PCN # 202
Notification Date:
January 28, 2021

Product / Process Change Notice

Chip process CP216, N-Channel field effect transistors, wafers and bare die.

Figure 1: CP216 Chip Geometry (Discontinued)

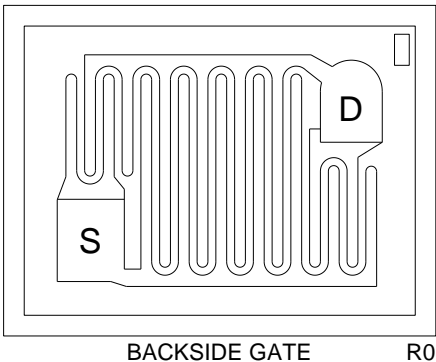
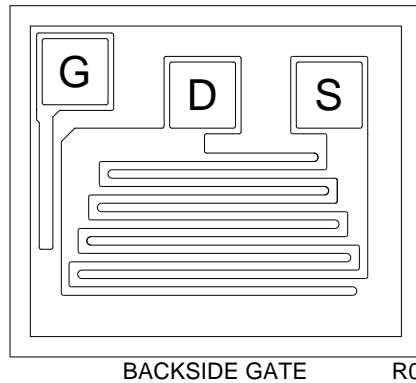
The CP216 wafer process has been discontinued and is being replaced with the CP226V wafer process. See Figures 1 and 2 for details.

The CP216 wafer process has been replaced in order to enhance manufacturing process controls and device performance. This change will help ensure an undisrupted supply of product.

Wafer Diameter: 4 inch
Die Size: 21 x 16 mils
Die Thickness: 7.9 mils
Bond Pad Size (Drain): 3.3 x 4.5 mils
Bond Pad Size (Source): 3.3 x 4.5 mils
Topside Metal: Al (10,000Å)
Backside Metal: Au (3,250Å)

Wafer Diameter: 5 inch
Die Size: 20 x 17 mils
Die Thickness: 7.1 mils
Bond Pad Size (Drain): 3.2 x 3.2 mils
Bond Pad Size (Source): 3.2 x 3.2 mils
Bond Pad Size (Gate): 3.2 x 3.2 mils
Topside Metal: Al (30,000Å)
Backside Metal: Au (9,000Å)
